**HealthSouth**

Hospital, 20-Bed

RECORD DRAWING & CERT.

**DRAINAGE PLAN & CALCULATIONS**

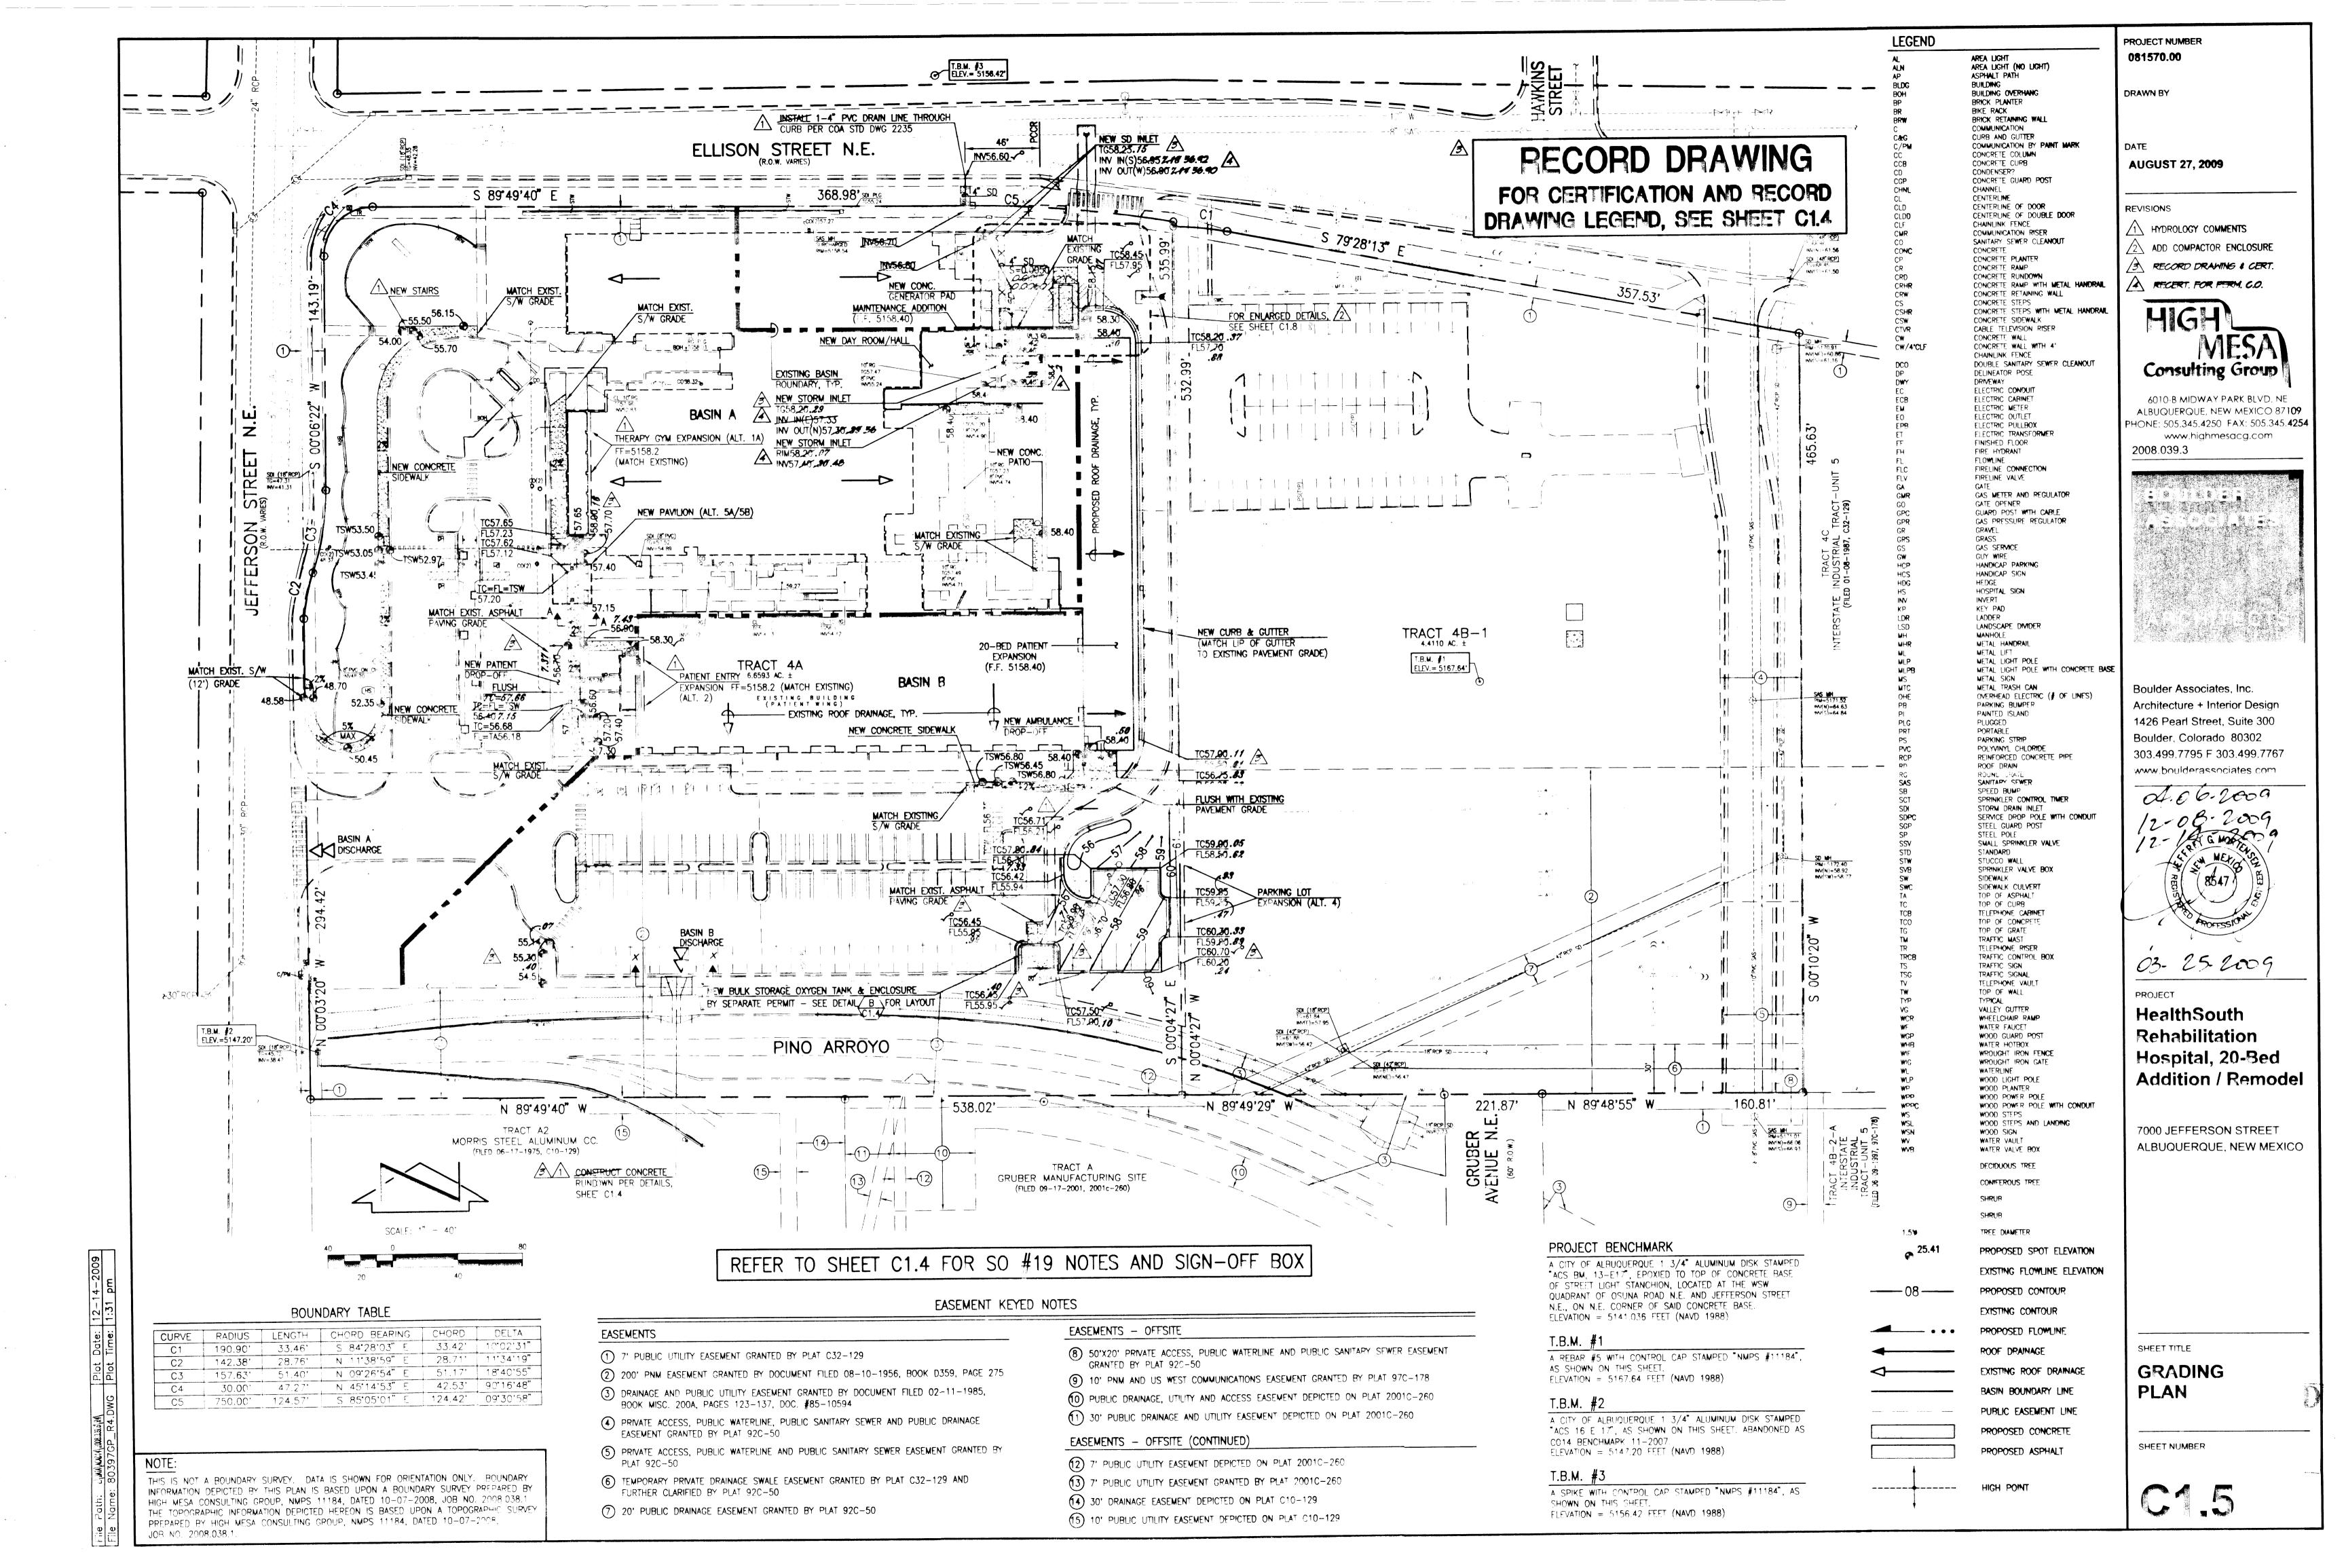
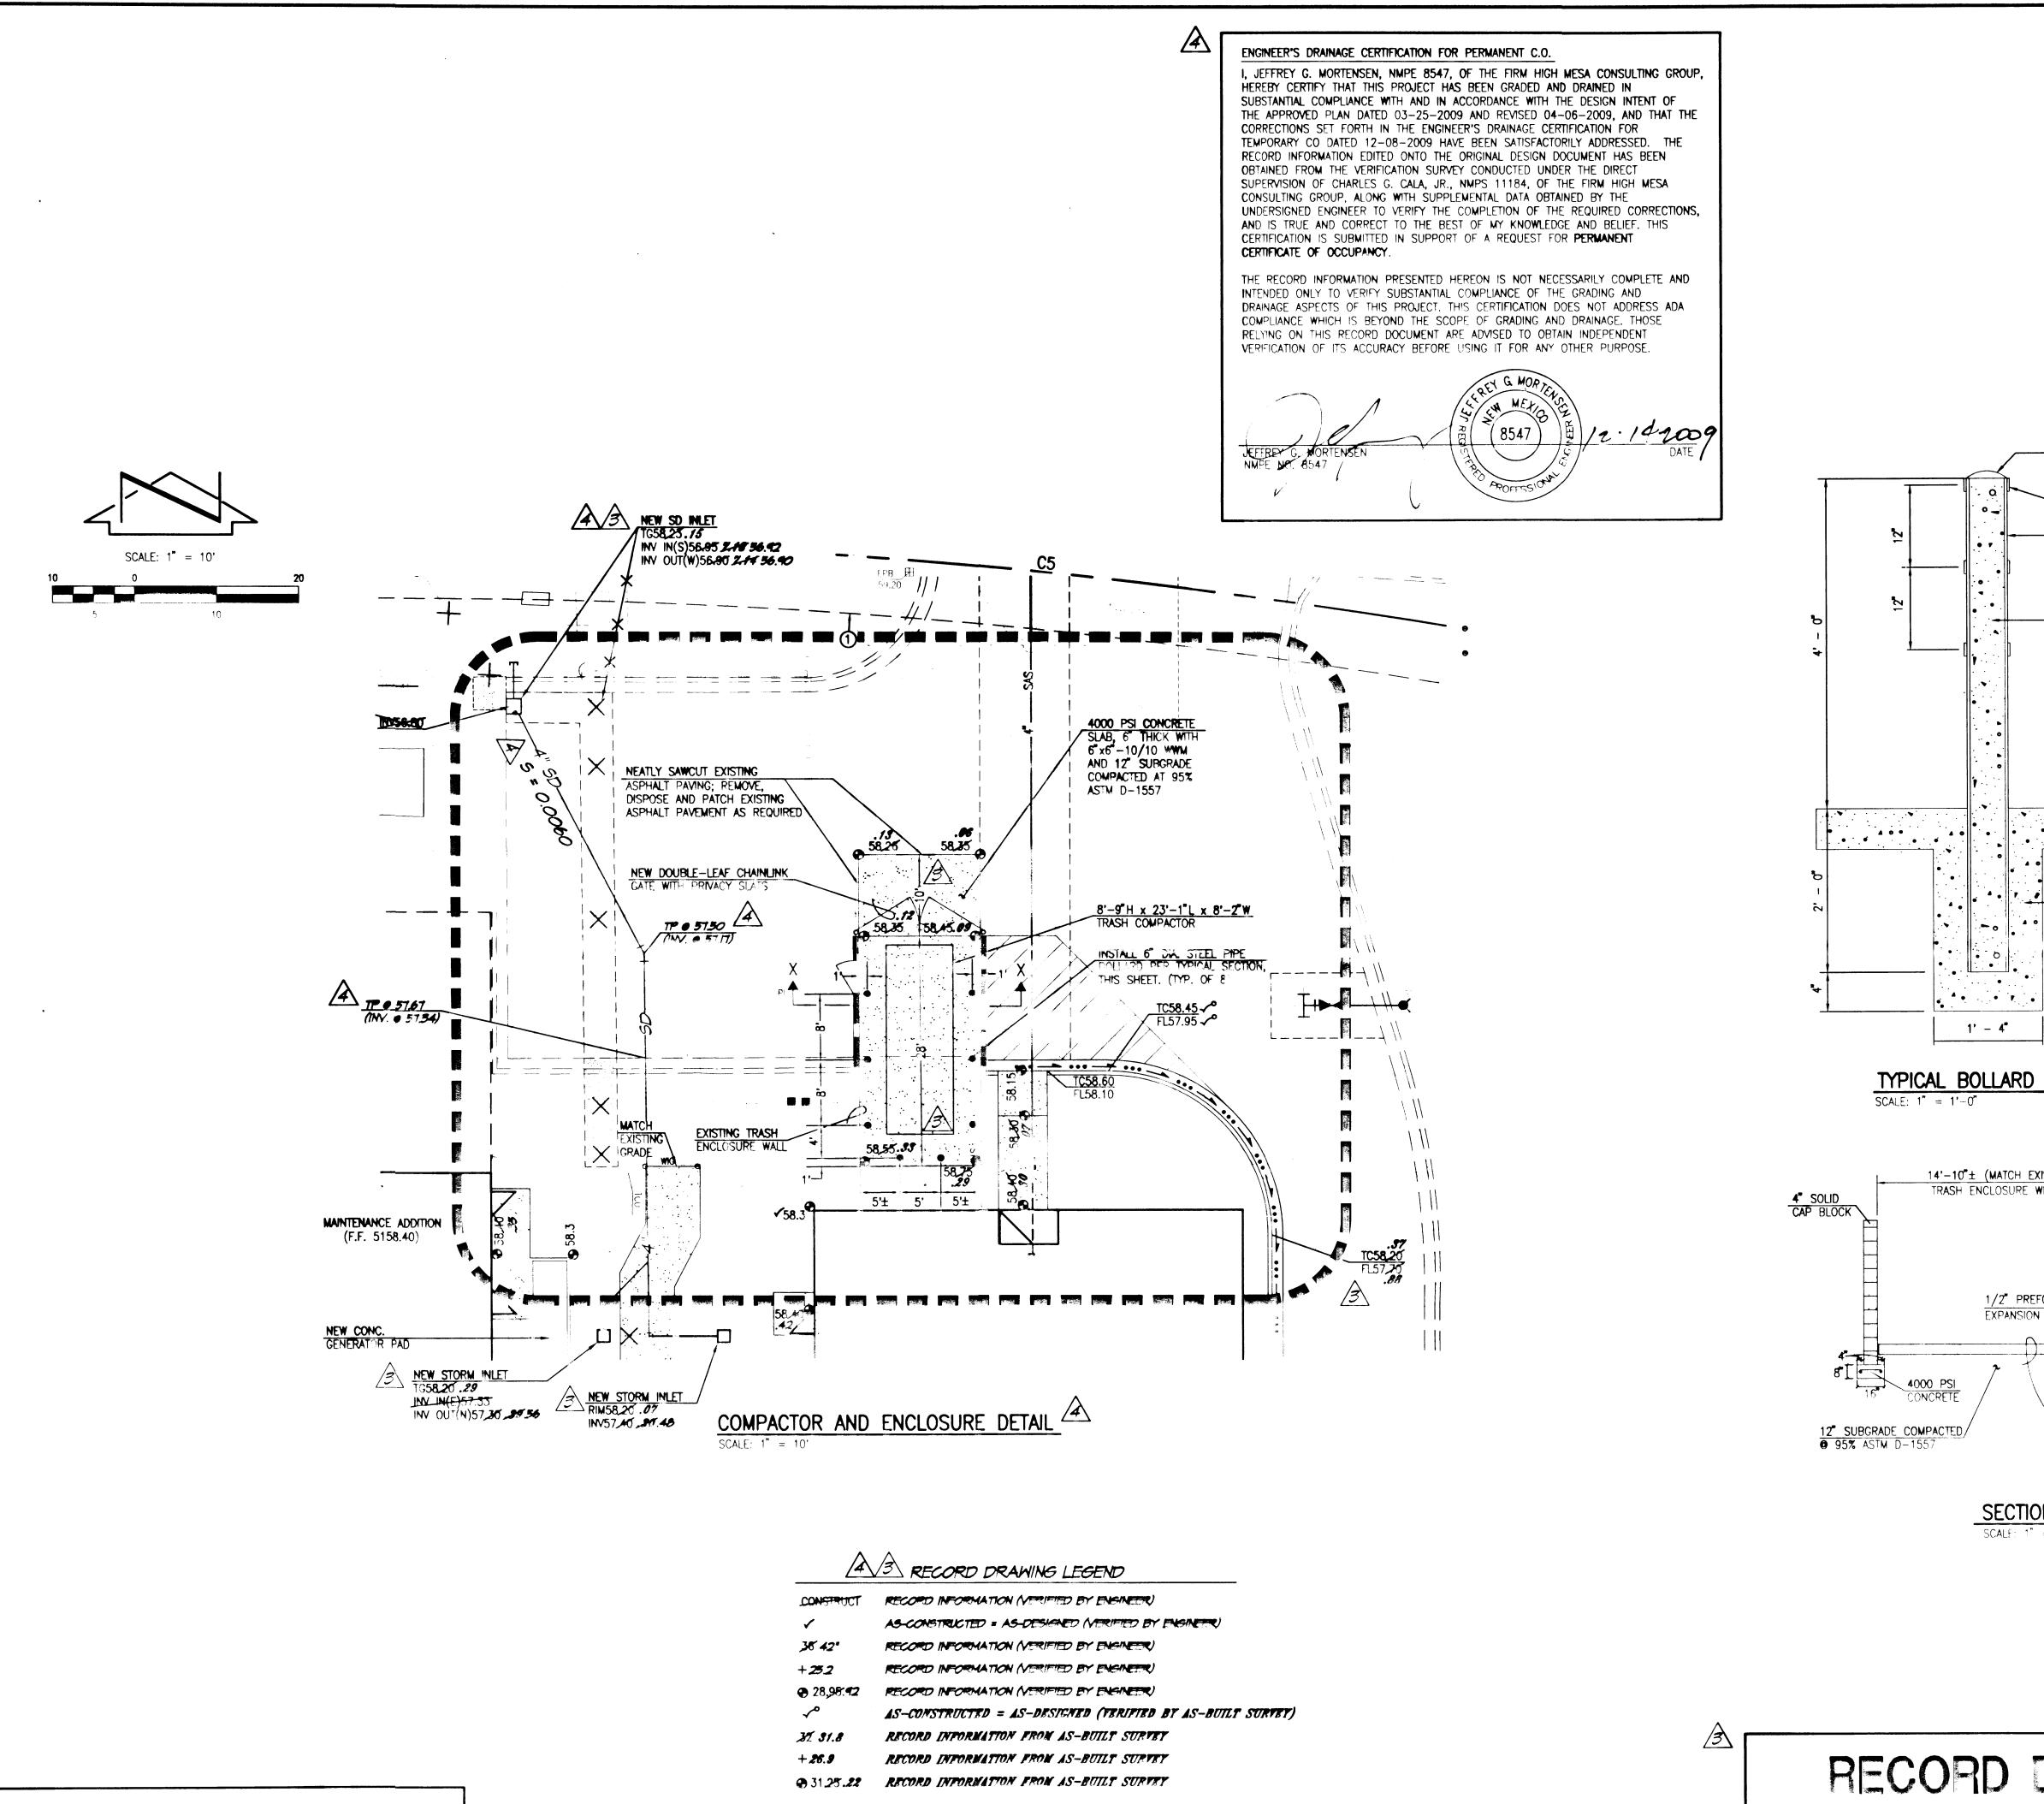
THE FOLLOWING EXCEPTIONS ARE NOTED AND MUST BE CORRECTED AND RE-CERTIFIED AS A CONDITION FOR PERMANENT CERTIFICATE OF OCCUPANCY:

- 1. THE 4" PRIVATE STORM DRAIN AT THE NORTHEAST CORNER OF THE SITE WAS CONSTRUCTED TOO FLAT (S = 0.002 + /-) AND MUST BE MODIFIED TO A MINIMUM SLOPE OF S = 0.0050AS DESIGNED AND APPROVED.
- 2. UPON COMPLETION OF THE ABOVE REFERENCED CORRECTION, RE-CERTIFICATION BY THE ENGINEER IS REQUIRED TO SUPPORT ISSUANCE OF A PERMANENT CERTIFICATE OF OCCUPANCY.
